# **Chapter II**

## **Planning and Financial Management**

## 2.1 Planning and Designing of the Project

**Chart 2.1: Component wise increase in project cost**

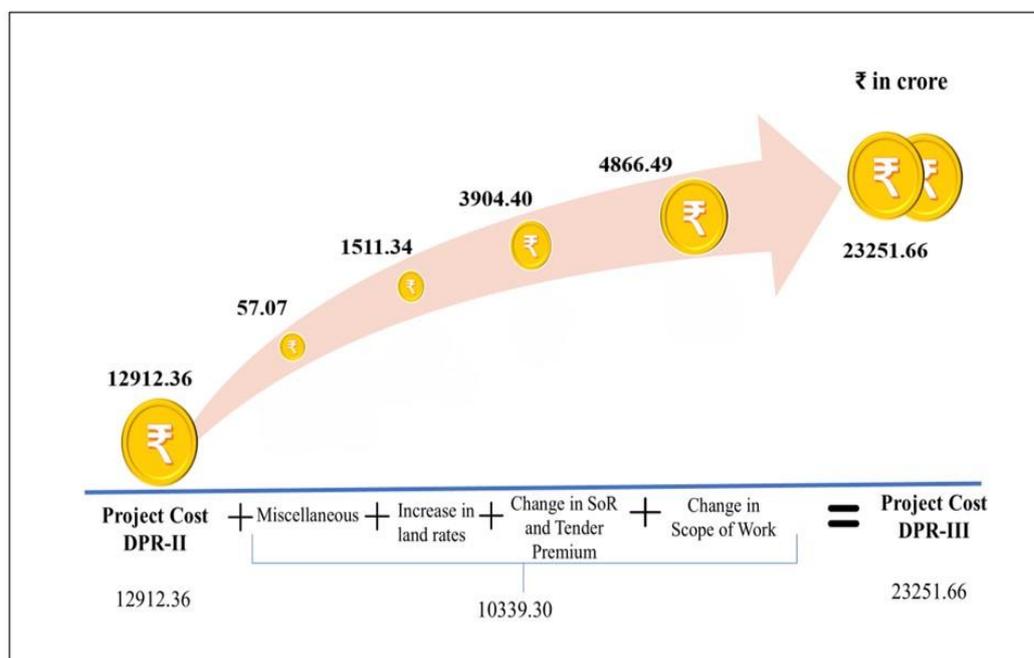
As illustrated above, the major factor in escalation of the project cost was change in scope of works due to revision of project design and alignment as explained in *Paragraph 2.1.2*. The other contributing factors were revision in Schedule of Rates and increased cost of land due to the delay in its acquisition.

The reply was not acceptable since in DPR-II, there was provision for construction of storage tanks for drinking water under the Project itself, even when the capacity of the envisaged Balancing Reservoir was 5.78 TMC. In DPR-III, the above storage tanks were dispensed with, and the drinking water was envisaged to be stored in dedicated storage spaces within Minor Irrigation tanks by the user departments. Hence the above justification offered for reduction in capacity of Balancing Reservoir was not acceptable as the provision for storage tanks was available in both the DPRs.

Government replied (March 2024) that the design changes were due to the reduction in capacity of the Balancing Reservoir to two TMC. This was necessitated due to the construction of separate dedicated storage space for drinking water within the existing Minor Irrigation tanks to be undertaken by the user departments such as RWS, KUWSDB and BWSSB. The availability of the above storage locations obviated the necessity for construction of Balancing Reservoir with higher capacity.

**Chart 2.2: Estimated Yield (DPR) Vs Actual Yield (recorded data at weirs)**

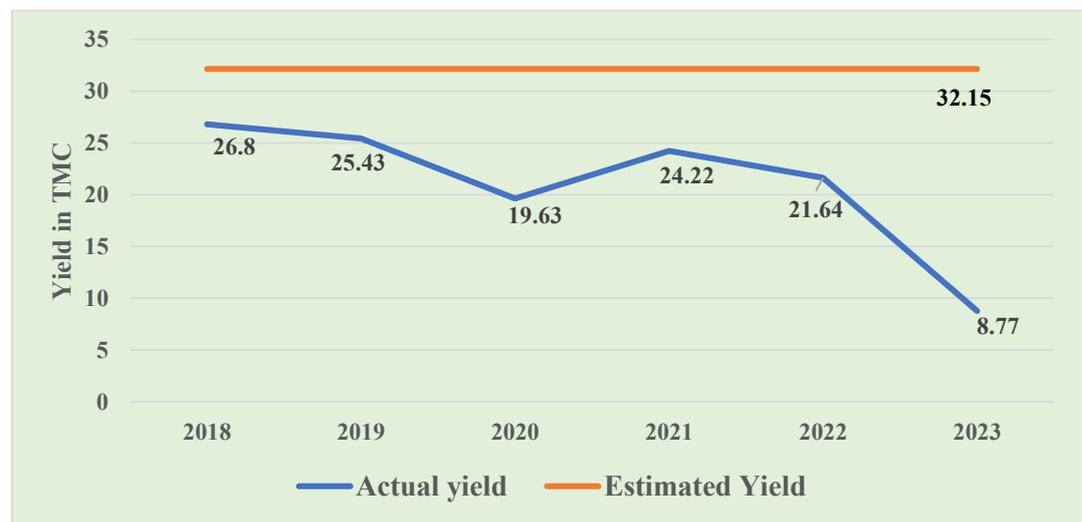
Results suggest that during 2018-23, maximum yield (in the year 2018 & 2019), was less than the estimated yield (32.15 TMC) as per the DPR. Highest available volume of 26.80 TMC was in the year 2018 and lowest was 8.77 TMC in the year 2023.

From **Table 2.3**, it can be observed that for a period of 139 days, the available volume of water in the eight weirs ranged between 7.20 TMC to 24.7 TMC as against the estimated volume of 32.15 TMC in DPR. Adopting the calculation methodology in the DPR, 50 per cent dependable volume comes to 19.12<sup>18</sup>TMC as against the estimated 31.54 TMC and the divertible yield was 14.55<sup>19</sup> TMC as against 24.01 TMC. This indicated the possibility of non-availability of the estimated quantity of water as projected in the DPRs.

In view of the above, the possibility of the actual availability of water being less than the estimated yield as per the DPR cannot be denied. The pumping capacity of 85 cumecs<sup>22</sup> was planned for pumping divertible yield of 24.01 TMC in 93 days. However, if the divertible yield gets reduced to 14.55 TMC as per audit calculation, the pumping capacity can be reduced to 52 cumecs. In this scenario, the possibility of installed capacity of machinery and structures to pump and carry the diverted water to the beneficiary area being in excess of requirement, cannot be ruled out. Government replied (March 2024) that flow assessment carried out in DPR was for a longer period of more than 30 years as compared to the flow data of six years

*Recommendation 3: VJNL should make use of reliable data for the calculation of flow and availability of yield while planning a Project.*
